## Husqvarna 37

### STARTER DEVICE

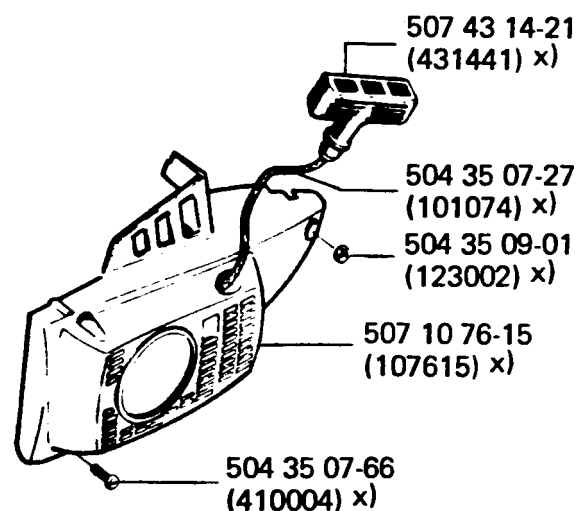
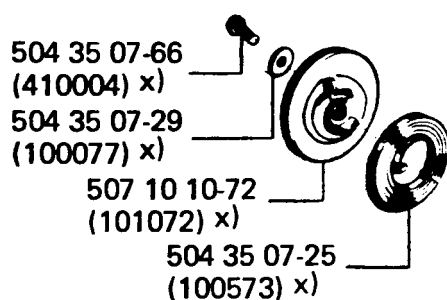
An improved mounting of the starter pulley (with screw instead of a circlip), has been introduced from serial number 139545. Also the post for the pulley is larger on the new version.

A new starter device compl. will replace the previous one.

507 10 10-72 (101072) <sup>x)</sup>	starter pulley (ø in hole 9 mm.)
504 35 07-66 (410004) <sup>x)</sup>	screw
507 10 76-15 (107615) <sup>x)</sup>	fan cover

501 71 99-01 (107602) <sup>x)</sup>	fan cover, replaced by 501 71 98-01 (107609) <sup>x)</sup>
	starter device compl.
